Work Order ID 105154

Item Name: Fwd Crosstube - High

D212-664-141/-141B
ASSEMBLY DETAIL D

DRAWING NO. D212-664-141	TITLE XTUBE ASSY (205/212/412 HI FWD)	REV. D	DART AEROSPACE LTD ENGINEERING ORDER		D.E.O. NO. D212-664-141-D-1	SHEET NO. SHEET 1 OF 2	SCALE NTS
DRAWN	CHECKED	MFG. APPR.	APPROVED	DE APPR.			
DATE 11.04.07	DATE 11.04.11	DATE 11.04.12	DATE 11/04/12	DATE 11.04.12

**D212-664-141/-141B
ASSEMBLY DETAIL**

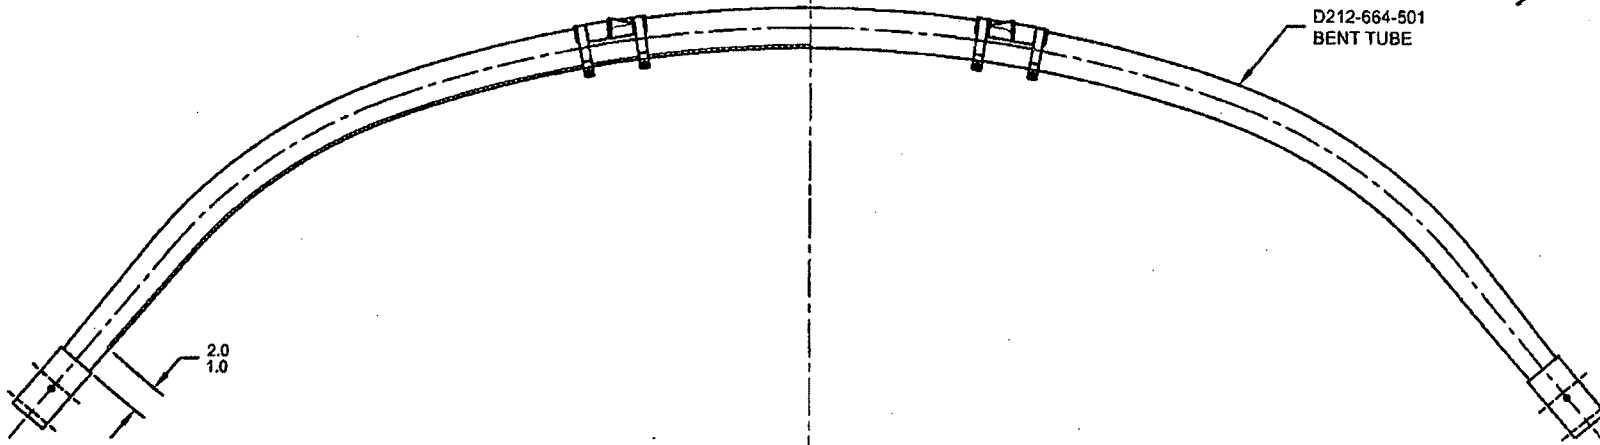
ADD AN INSPECTION WINDOW TO UNDERSIDE OF CROSSTUBE.

- 2) FINISH: CHEMICAL CONVERSION COAT PER DART QSI 005 4.1
PRIME INSIDE AND OUTSIDE PER DART QSI 005 4.2
MASK UNDERSIDE OF CROSSTUBE AS SHOWN (HATCHED AREA) AND
PAINT OUTSIDE PER DART QSI 005 4.2
REMOVE MASKING AND APPLY CLEAR COAT

MASK AREA PRIOR TO PAINTING,
REMOVE MASKING AFTER PAINT
AND APPLY CLEAR COAT
